PRELIMINARY/ FINAL LAND DEVELOPMENT PLAN FOR

REPLER INVESTMENTS LP.

CENTRAL PA SWEEPERS

RE: 380 Hershey Road
Preliminary/Final Land Development Plan
Township Permit No. 23-05-FLDP
East Hempfield Township, Lancaster County, Pennsylvania
JHA No. 2024-0843

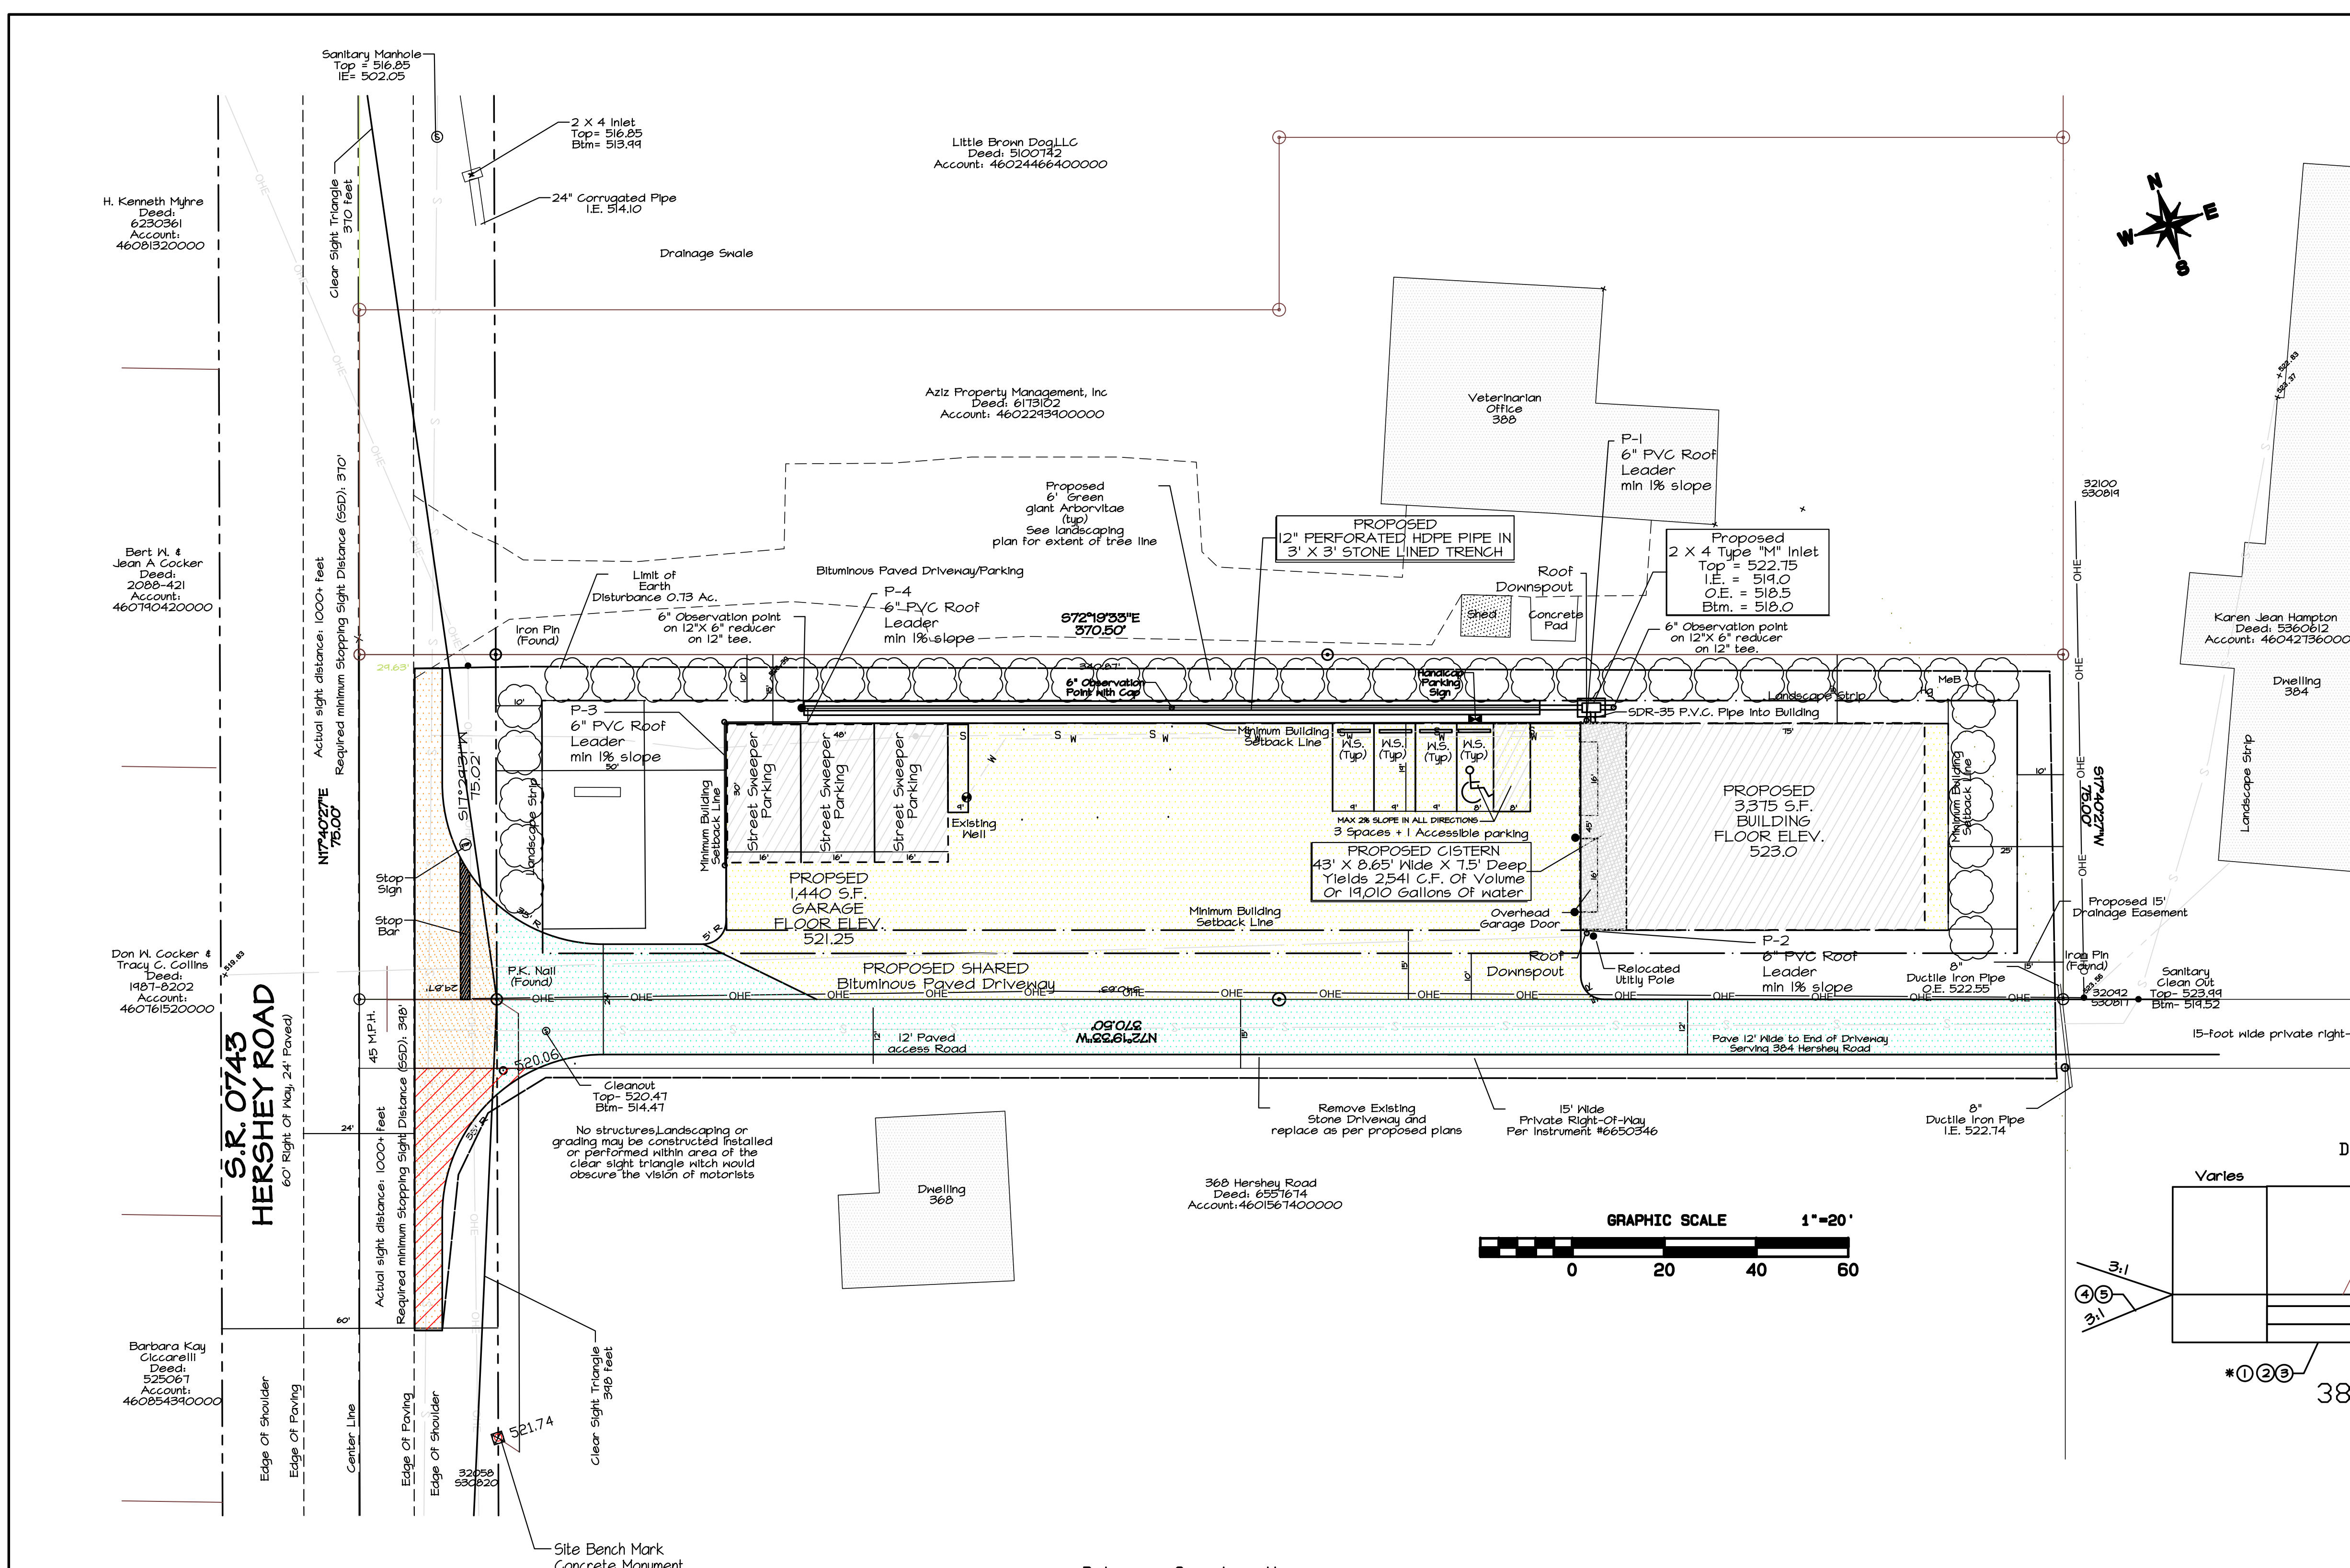
43. The designer shall clarify the meaning of the hatches on the eastern and western portions of the subject tract shown on Sheet 4 of the plans (113-43.J(2)).

Response: The shading of these areas has been removed as shown on revised Sheet 4.
44. The center 6" Observation Point With Cap shall be shown in the Stormwater Collector Trench Controls detail (113-43.J(5)).

POST CONSTRUCTION STORMWATER MANAGEMENT PLAN
 380 HERSHEY ROAD
 ELIZABETHTOWN, PA 17022

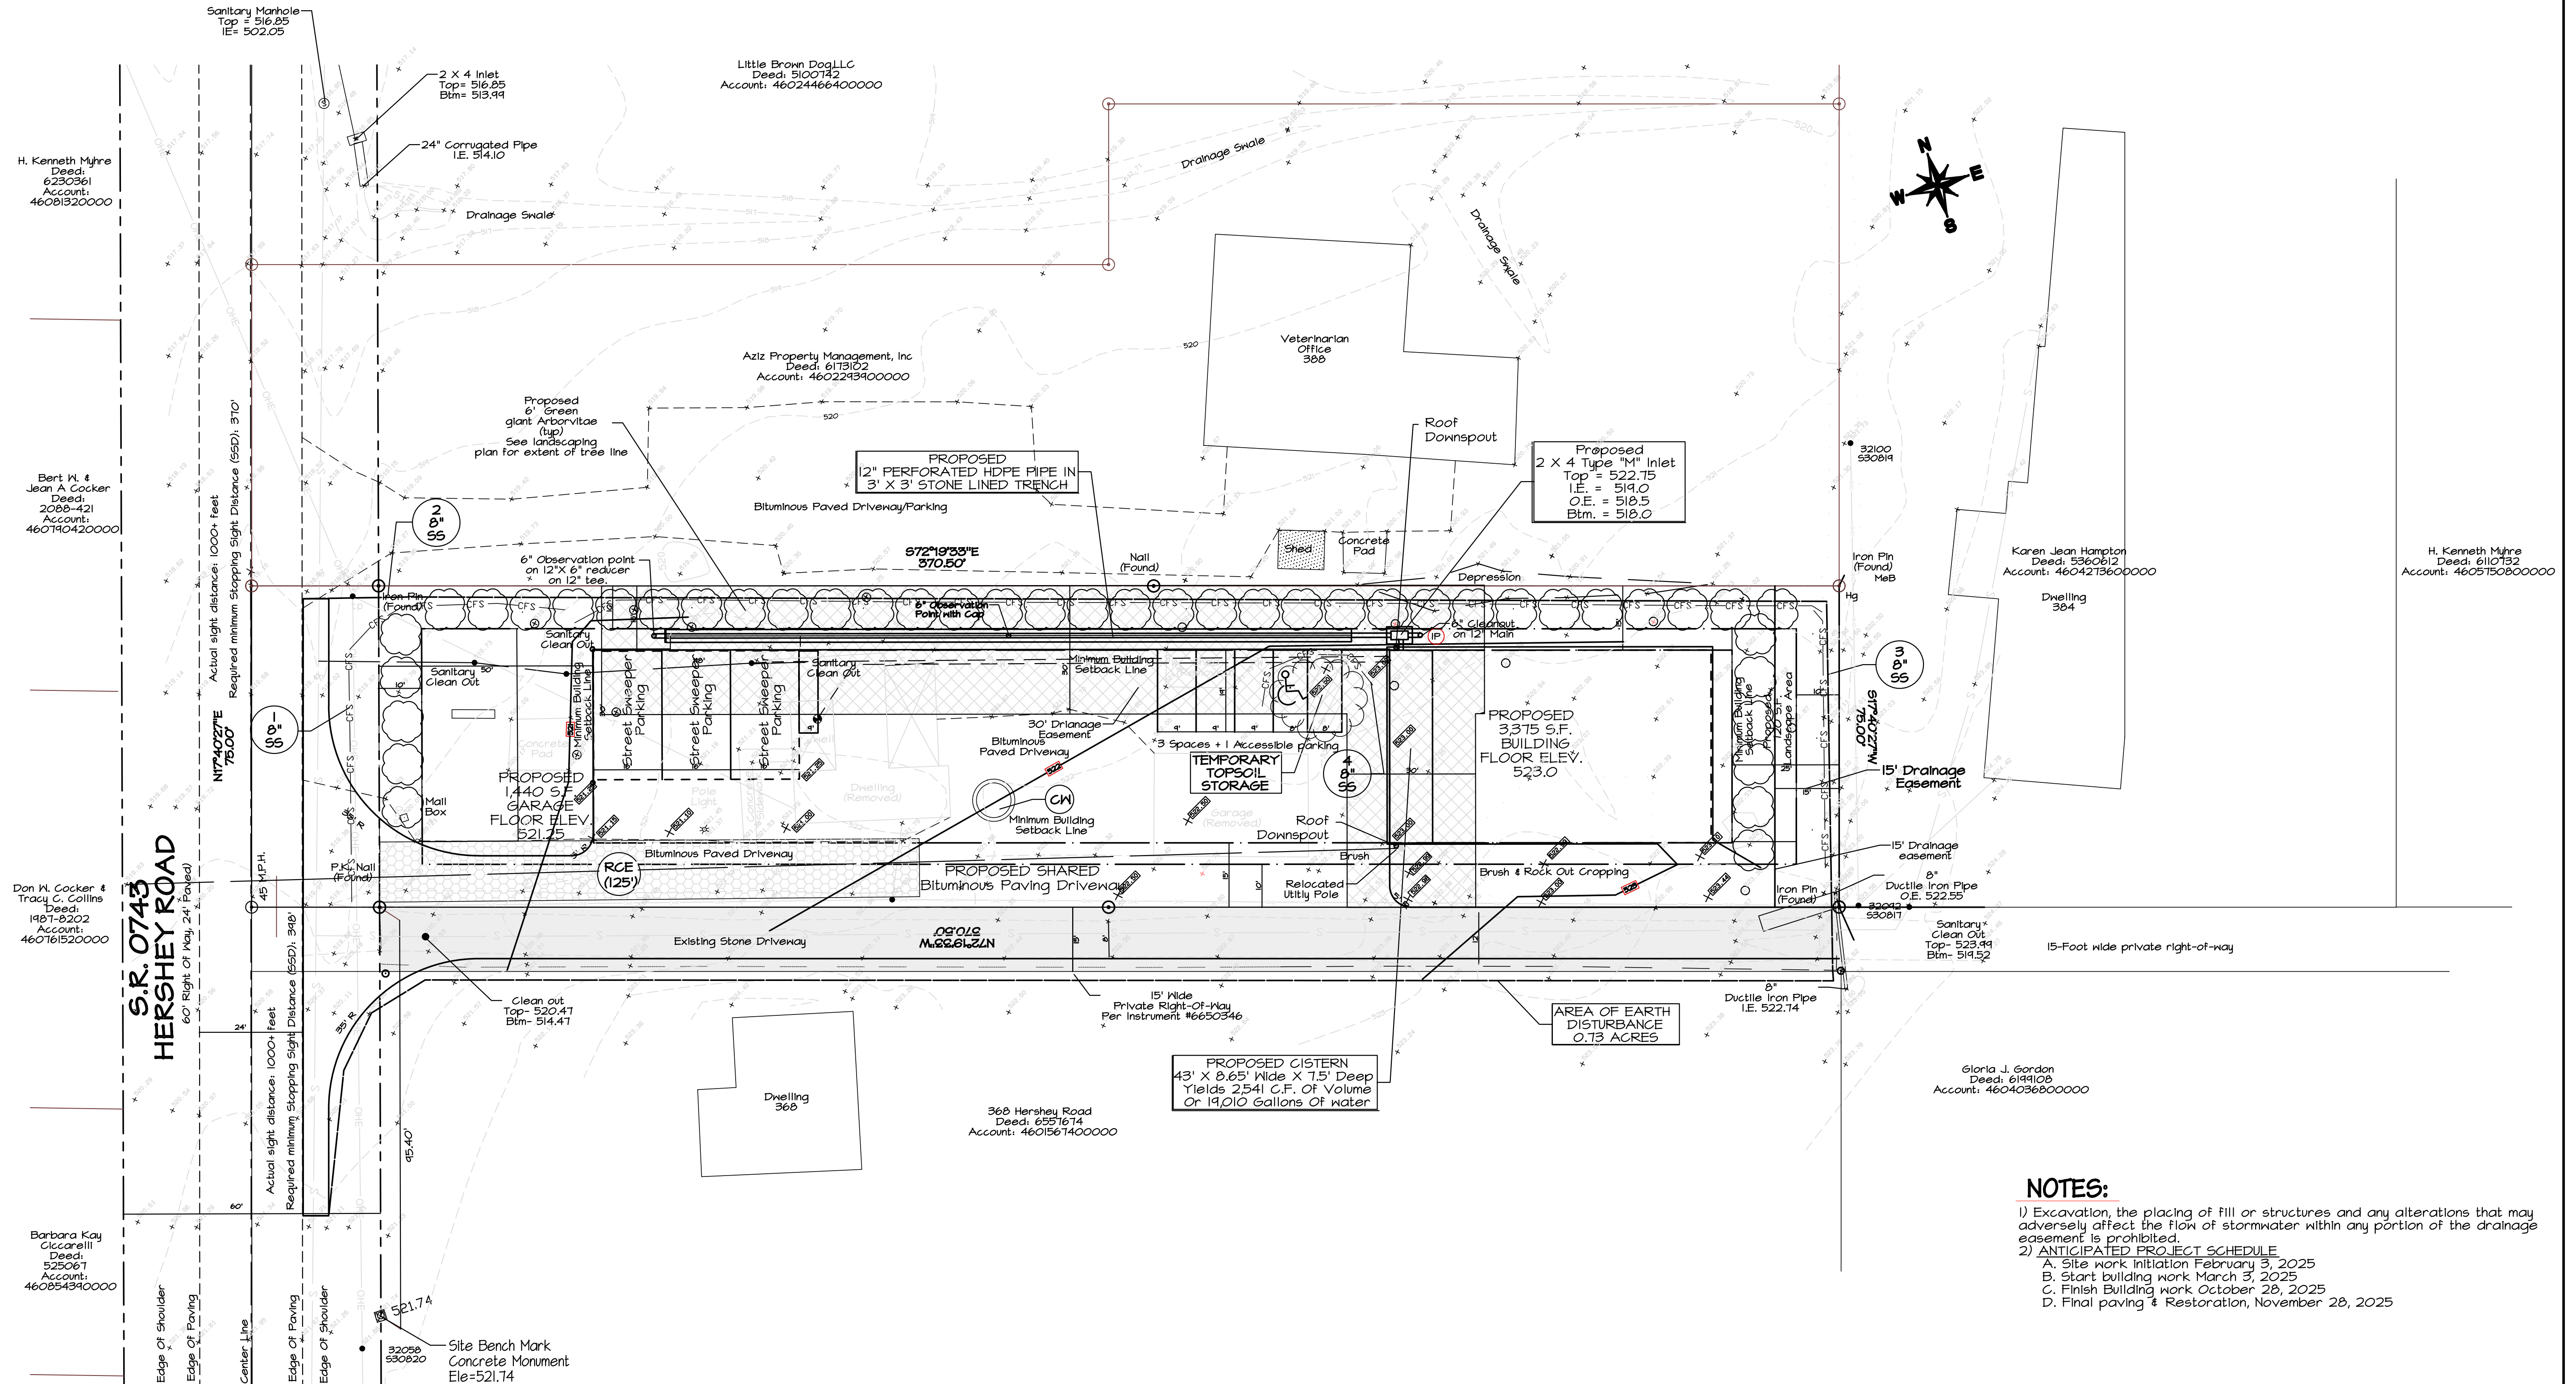
24. A minimum 30 foot wide access easement shall be provided for the stormwater facilities. The requirements in the Maintenance Of Drainage Easement note on Sheet 5 shall be included in the new deed. The applicant shall be responsible for completing a declaration of easement and stormwater management agreement in a form that is acceptable to the Township Solicitor (119-56.D, 119-56.E, 113-31.R & 113-31.Q).

26. The following erosion and sediment control items shall be addressed (113-31.E & 113-43.K):
- Design information, including calculations, shall be provided for compost filter sock #4 shown on the plans
 - The "Anticipated Project Schedule" on Sheet 5 of the plans shall be updated.

Response: A minimum of a 30-foot wide easement will be provided for the stormwater facilities within the site, except the drainage easement at the rear of the property. A waiver is being requested for the 15' wide drainage easement to the rear of the property. The new deed for the property will include the requirements in the Maintenance of Drainage Easement note on Sheet 5.

ILLUMINATION PLAN

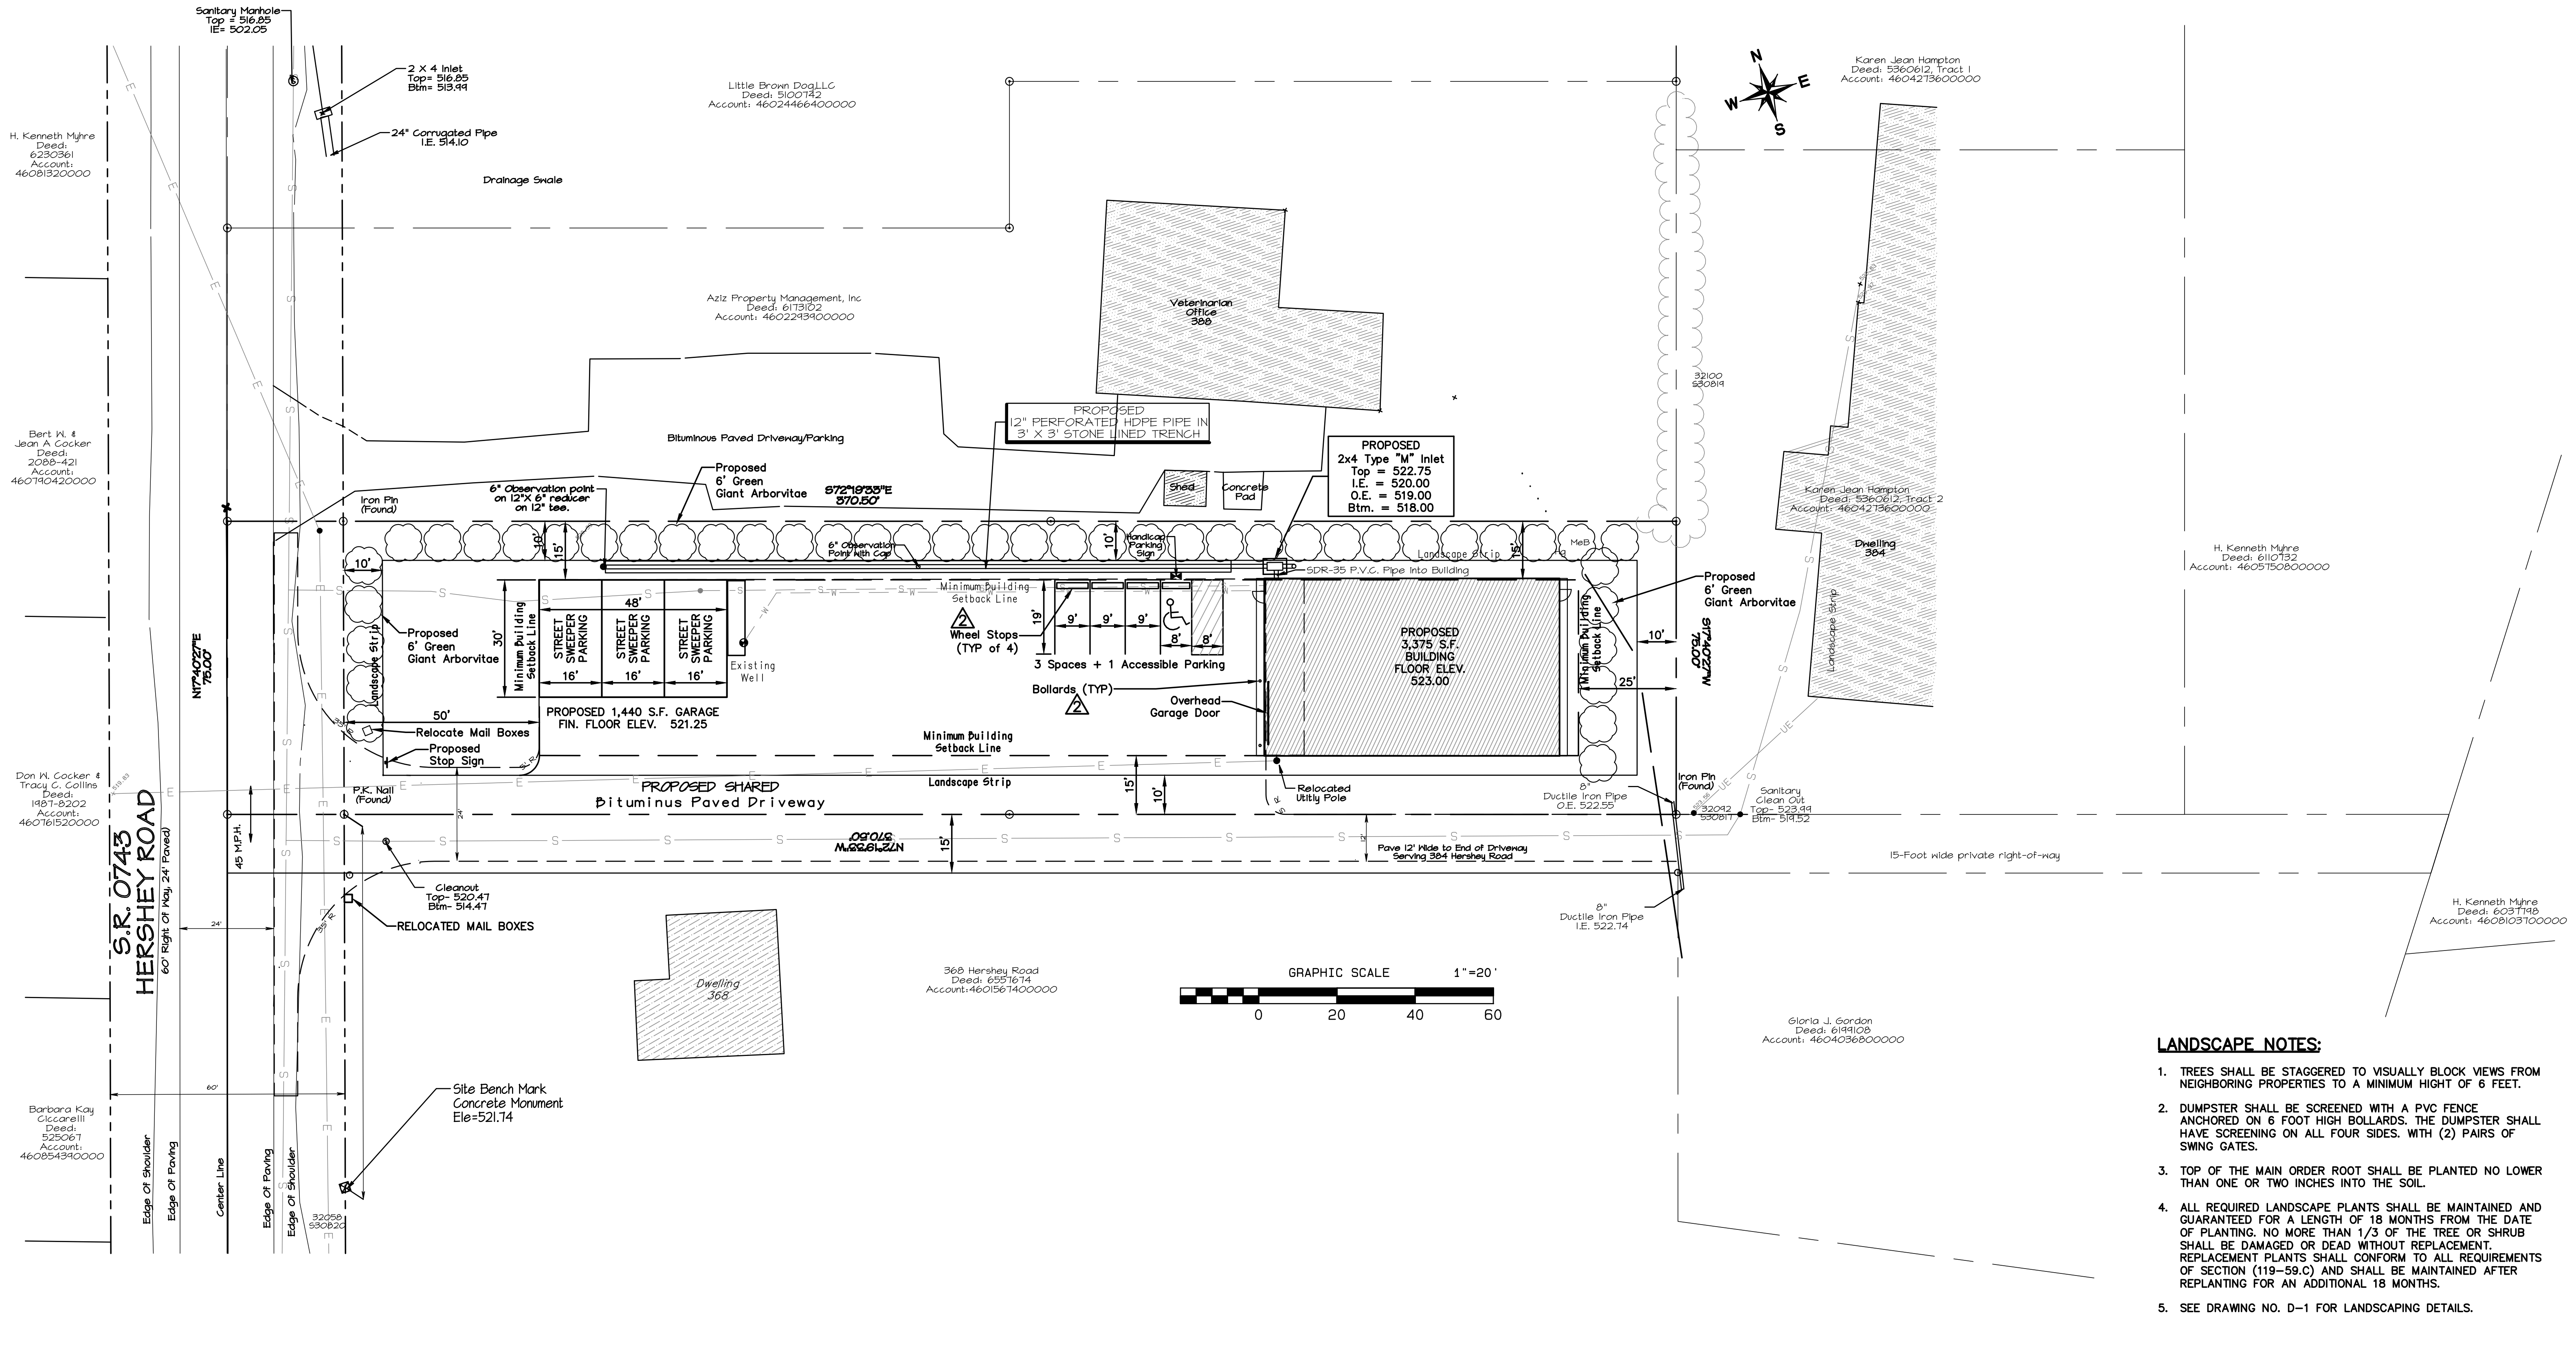
4. The linetype and linetype color of the right-of-way shown in the plan view is inconsistent with that shown in the legend (119-31.A(4)). The fence linetype shown in the legend on Sheet 5 is inconsistent with the fence linetype shown around the dumpster on Sheet 8.

Response: The linetype and linetype color of the right-of-way is now consistent with the legend. The fence linetype shown on the legend is not required since the dumpster enclosure has been removed from the plans.
